BMW Motorrad USA Service Information Bulletin

****Notice of Recall 14V-320****

Subject: Replacing Rear Spring Strut

Model: R 1200 RT (K52, 0A03/0A13) with Dynamic ESA as optional extra (option code 0191 or 0233)

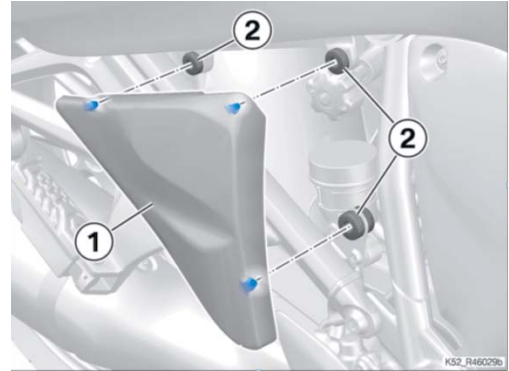
Aftersales Solution: All vehicles affected by this issue must have the Dynamic ESA rear spring strut or the dummy spring strut removed and a new, improved Dynamic ESA spring strut installed (see attached work item 00 60 296 for a description of the procedure).

The green spot is the identifying mark for the new, improved Dynamic ESA spring strut.

8 Removing rear spring strut

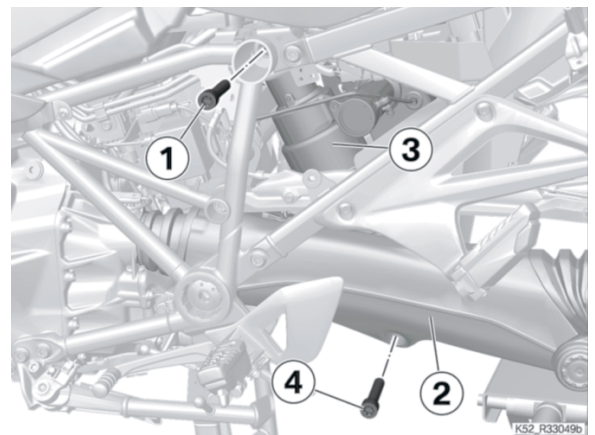
Remove screw (1), if necessary lifting or lowering swingarm (2) slightly to take the strain off spring strut (3).
Fully lower swingarm (2).
Remove screw (4).
Remove spring strut (3).

9 Installing rear spring strut

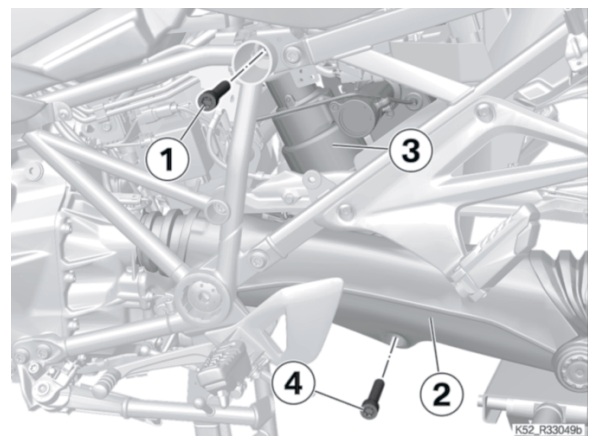
Clean the threads.
Install spring strut (3).
Insert original screw (1).
Slightly raise swingarm (2).
Install original screw (4) and tighten screw (1).

Tightening torques	
Spring Strut to Frame	
M12 x 1.5 x 60 Thread-locking compound (Loctite 2701,High strength)	100 Nm
Spring Strut to Swingarm	
M12 x 75 - 10.9 Thread-locking compound (Loctite 2701,High strength)	100 Nm
